Access Compliance Report

Public Rights-of-Way

(Curb Ramps)

Intersection ID: 10181	Main Street: BACON_AV	Cross Street: ROSLYN_AV	Location: S
ADA ID: 5DE6902BDCB5	Ramp Type: PerpDiag	Initial Pass/Fail: Fail	Overall Compliance: No
		Severity Score: 47.5

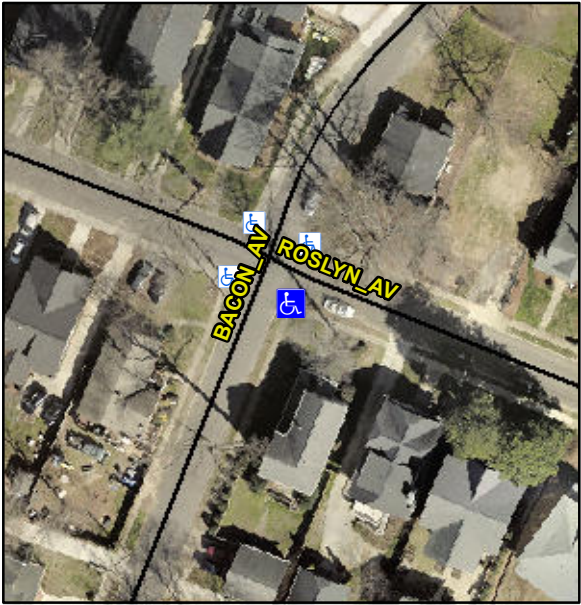
Codes/Mitigation Info/Possible Solution			Field Measurements/Component Compliance		
	Possible Solutions:		Compliance	Description	Data
	Remove & Replace Curb Ramp With Two New Directional Ramps or Equivalent.		N/A	Ramp Length (in)	85.5
			No	Ramp Width (in)	28.0
			N/A	Flare Type LT	N/A
			N/A	Flare Slope LT (%)	N/A
			N/A	Flare Traversable LT?	N/A
			N/A	Landing Length (in)	N/A
			N/A	Landing Width (in)	N/A
			N/A	Landing Slope (%)	N/A
			N/A	Landing X Slope (%)	N/A
			N/A	Landing Curb? (Y/N)	N/A
			N/A	Shared Landing?	N/A
			N/A	Gutter Ponding?	N/A
			N/A	Gutter Lip Ht (in)	N/A
			N/A	Painted X Walk1?	No
				X Walk 1 Direction	To NE
			N/A	X Walk 1 Width (in)	N/A
				X Walk 1 Slope (%)	2.7
				X Walk 1 X Slope (%)	2.6
			N/A	Ramp inside XWalk1?	N/A
<p>Surveyor Notes:</p> <p>N/A</p> <p>PROW/ADA:</p> <p>Not Found, R304.5.1, R304.5.3</p>			N/A	Ramp Slope (%)	6.4
			No	Ramp XSlope (%)	6.3
			N/A	Flare Type RT	N/A
			N/A	Flare Slope RT (%)	N/A

N/A	Flare Traversable RT?	N/A
			N/A	DWS Provided?	N/A
			N/A	DWS Contrast?	N/A
			N/A	DWS Length (in)	N/A
			N/A	DWS Full Width?	N/A
			N/A	DWS Offset (in)	N/A
			N/A	Gutter Slope (%)	N/A
			N/A	Gutter X Slope (%)	N/A
			N/A	Painted X Walk2?	No
				X Walk 2 Direction	To NW
			N/A	X Walk 2 Width (in)	N/A
				X Walk 2 Slope (%)	2.8
				X Walk 2 X Slope (%)	4.9
			N/A	Ramp inside XWalk2?	N/A
			N/A	Clear Space?	N/A
			N/A	Clear Space to XWalk (in)	N/A
<p>Total Cost:</p> <p>\$ 3200.00</p>			N/A	Storm Grate/Utility Hazard?	N/A
				Storm Grate/Utility Type	
			N/A		N/A
			Yes	Surface Condition? (G/P)	Good
